MF01 Series Digital Flow Sensor

MFP01 Series Digital Flow and Pressure Sensor

Change Notification

MF01 Series Digital Flow Sensor

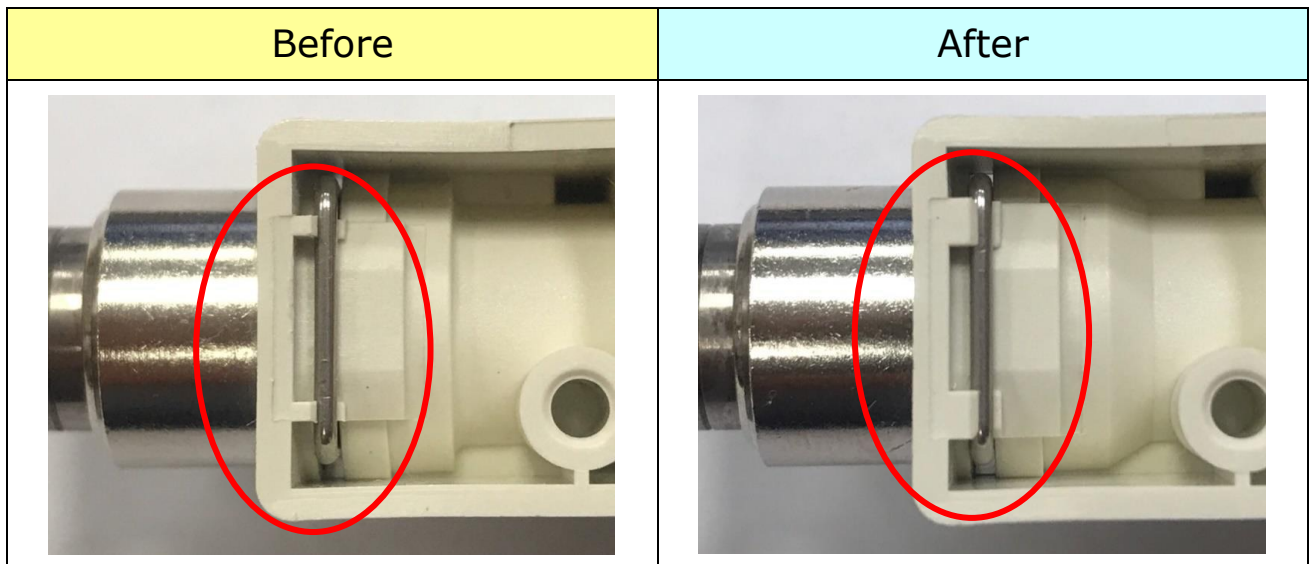
In order to strengthen the stability of the product, we will widen the fixing structure of the quick connector pin.

Take MF01 series for example.
